SERVICE BULLETIN

APPLICABILITY: 2026MY Outback

NUMBER: 12-283-26

SUBJECT: Loose Fitting Door Weatherstrip / Repair Procedure

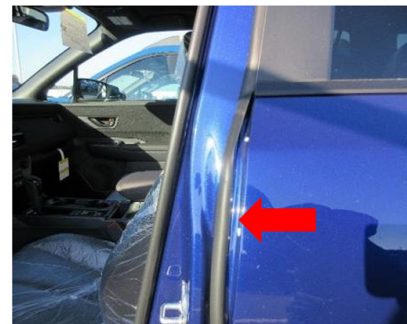
This service bulletin announces a repair procedure for the weatherstrips on the front of the rear doors. This strip can become loose over time from the front door being opened and closed. A new clip has been developed to have high rigidity to prevent the clip from losing tension over time. If the customer reports a loose weather door strip (Example below), follow the procedure outlined in this bulletin.

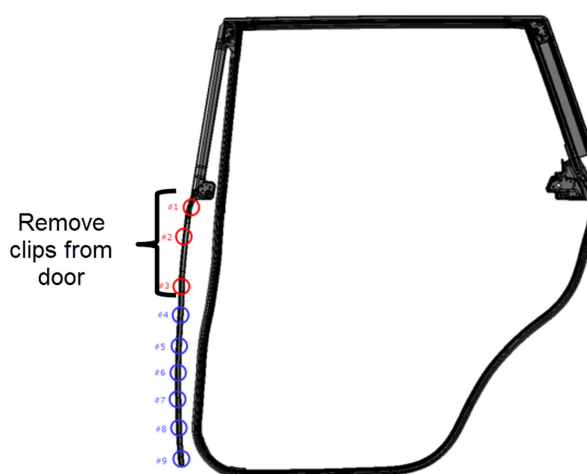
Qty	Description	Part Number
3 per side	CLIP	909130306

Note: The weather strip part numbers 63512AR001 and 63513AR001 incorporate these new clips, so the procedure does not need to be performed if replacing the weather strip.

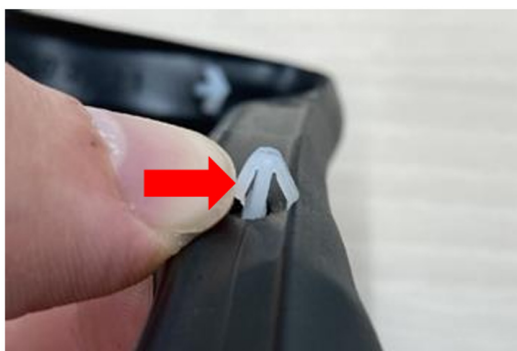
Step 2: Remove the top 3 clips from the rubber weatherstrip.

- Push the clip fingers together.

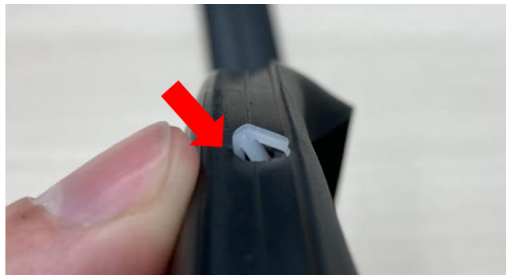
- Push down on the clip, feeding it into the hole.

- Remove the clip from the back side of the weatherstrip.

EB-10240

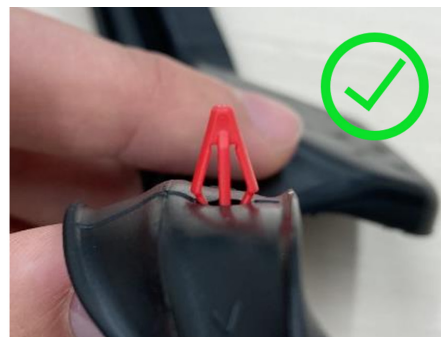
- The weatherstrip may tear if being pulled. Also, the weatherstrip clip may be damaged if being removed with excessive force.

- Replace the damaged weatherstrip clip with a new part.
- When fragments of the clip fall in the door panel, be sure to remove them.
